CALIFORNIA COASTAL COMMISSION

AMENDMENT REQUEST
STAFF REPORT AND PRELIMINARY RECOMMENDATION

Application No.: A-6-LJS-02-68-A1

Proposed Amendment: Modifications to the building footprint, setbacks and architecture of proposed single-family residence resulting in a two-story, 5,756 sq.ft. single family residence with attached three-car garage, pool, hardscape and landscape improvements on a 0.30 acre blufftop lot.

EXHIBIT NO. 2
APPLICATION NO.
A-6-LJS-02-68-A1
Site Plan
California Coastal Commission

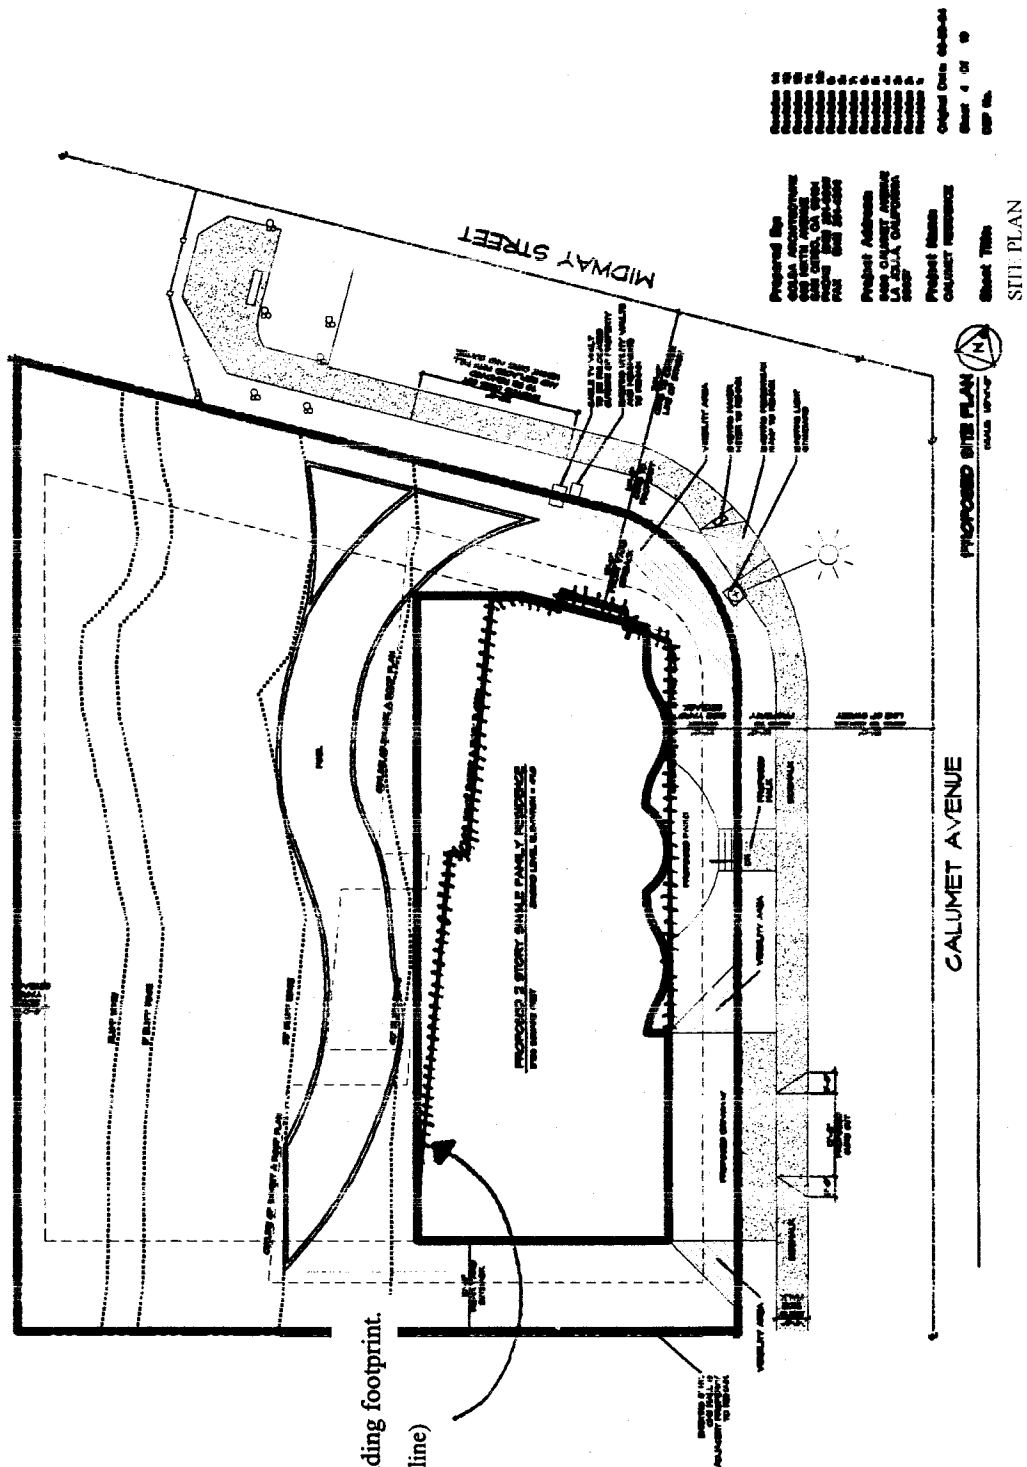
The proposed amendment largely consists of changes to the building architecture and building footprint resulting in the residence being sited approximately 10 ft. further seaward. Whereas, the previous building footprint resembled a rectangular-shaped residence, the newly proposed residence will have architectural recesses along the east façade that are curvilinear in shape to eliminate a "boxy" look and will have a substantial amount of glass along the western facade to create more of an "open" appearance. In addition, the other proposed changes include a slight reduction in square footage from 5,790 sq.ft. to 5,756 sq.ft., a reduction in height (from elevation +75.5 ft. to +72.2 ft. resulting in a difference of approximately three feet for the east elevation) of the new residence from the previous design, an increase in the width of the north yard setback area (approximately 1 ½ feet greater) adjacent to the designated public view corridor of Midway Street, and a change to the roofline of the residence eliminating a curved and projecting roofline and replacement with a flat roof which does not overhang or intrude into the public view corridor.

plan consists of a master bedroom with bath, two bedrooms with baths and a laundry room. The new residence is proposed to be sited a distance of 40 ft. from the bluff edge and the new swimming pool is proposed to be sited a distance of 25 ft. from the bluff edge, the same distance as originally approved. Special Condition No. 1 requires submittal of final plans in substantial conformance with the submitted plans to reflect the newly proposed design and other miscellaneous changes to the proposed residence through the proposed amendment. This is the only change to the condition.

EXHIBIT NO. 3

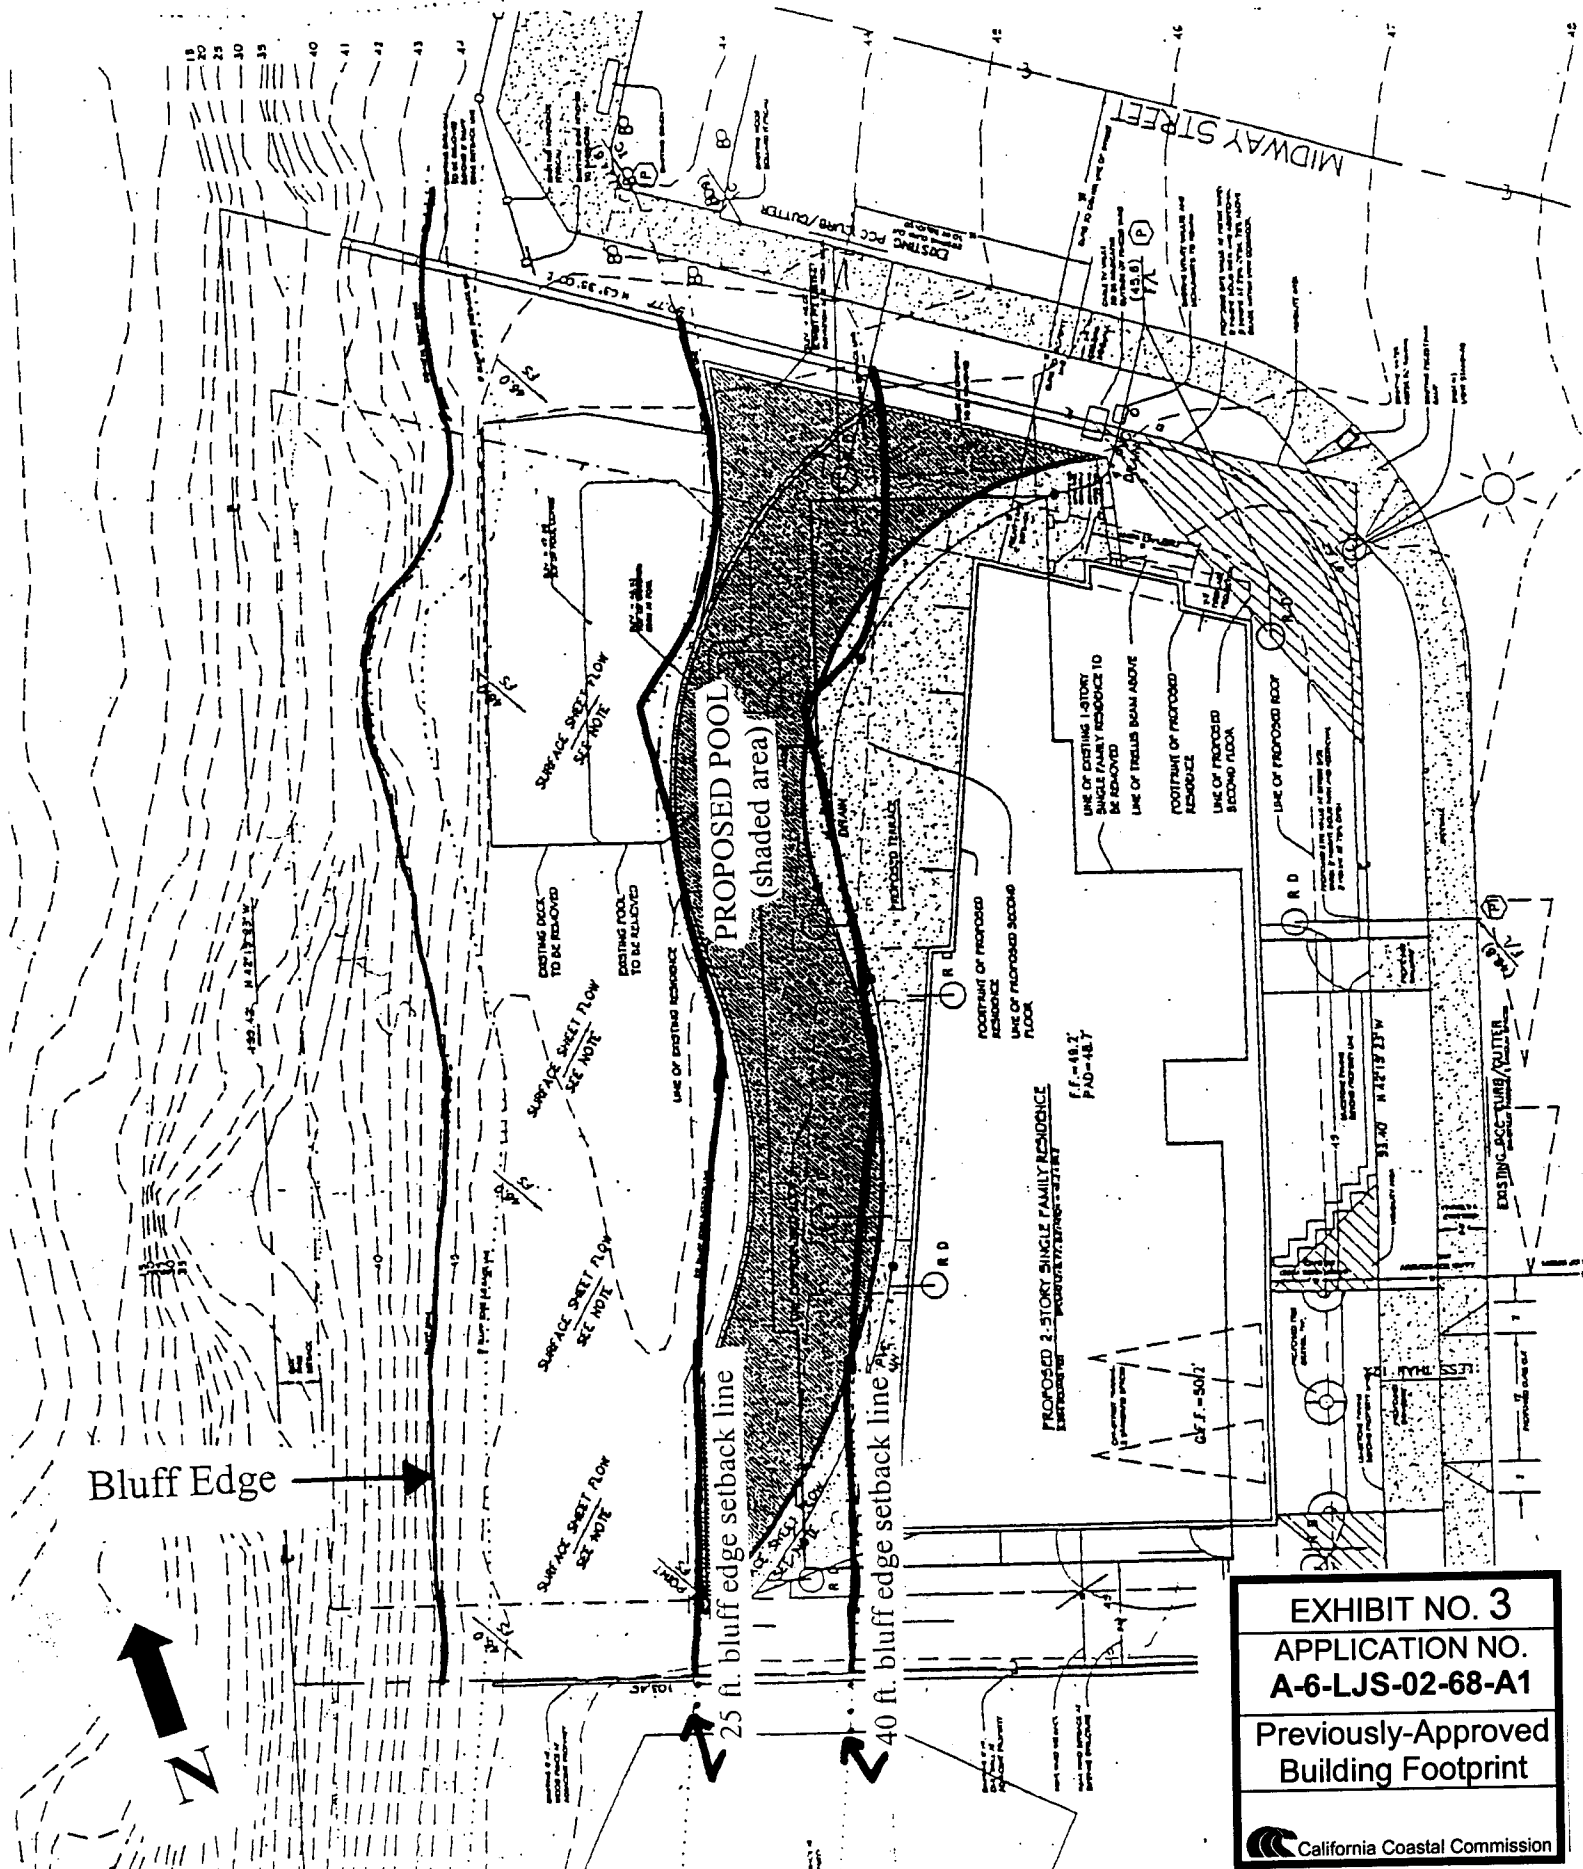
- a. All existing and proposed accessory improvements shall be identified. All accessory improvements (including, but not limited to, patios, decks, walkways, and open shade structures) proposed within the 25 ft. geologic setback area must be "at-grade" and located no closer than 5 ft. from the edge of the existing bluff, as delineated on Exhibit No. 3 to the May 21, 2003 staff report.

EXHIBIT NO. 4
APPLICATION NO. A-6-LJS-02-68-A1
Comparison of Revisions to roof design
 California Coastal Commission

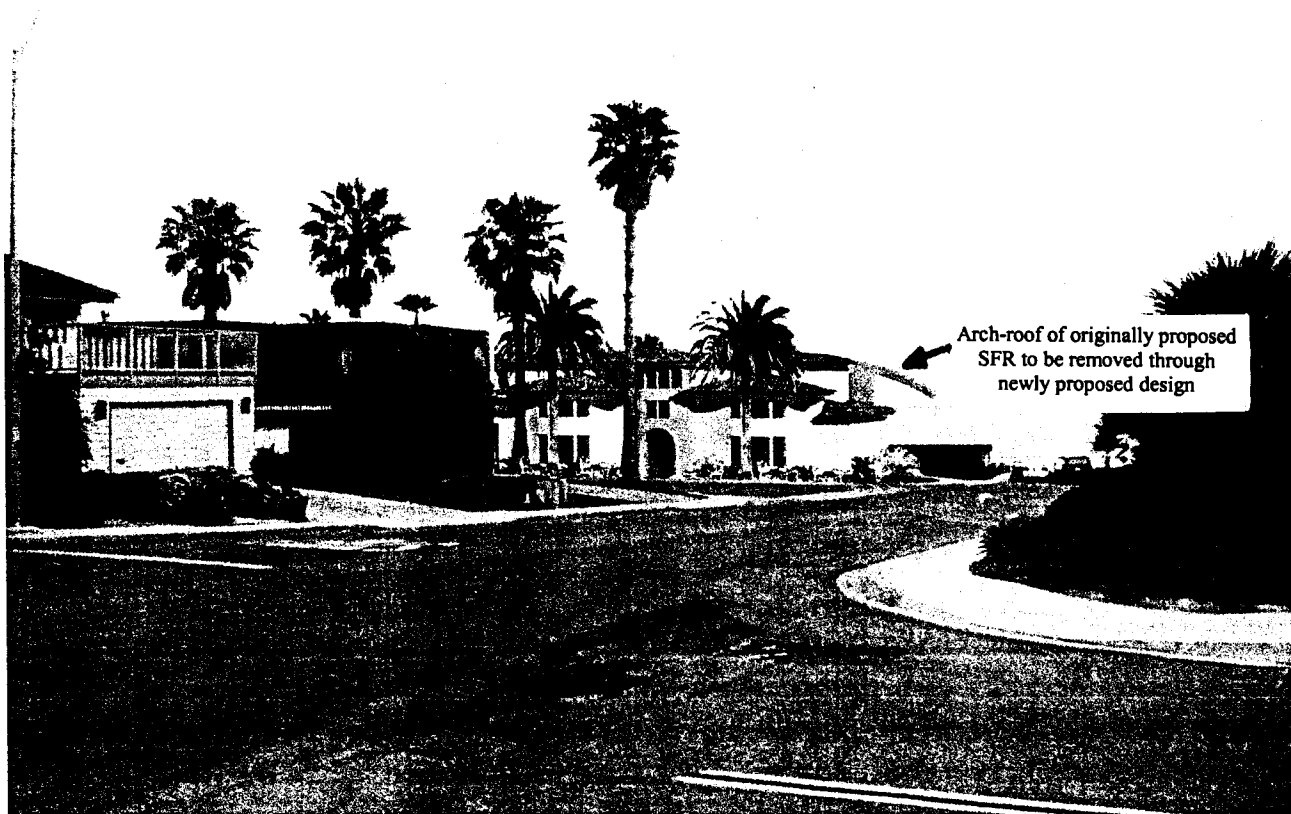
In addition, the change in architecture from modern to "bold and dynamic" (as described by the project architects) has also resulted in a significant change to the roof of the proposed residence. Whereas, the original roof was arched in shape and protruded into the designated public view corridor while looking west and southwest, the new roofline is completely flat and eliminates all projections in the ocean horizon or blue sky view across the subject site.
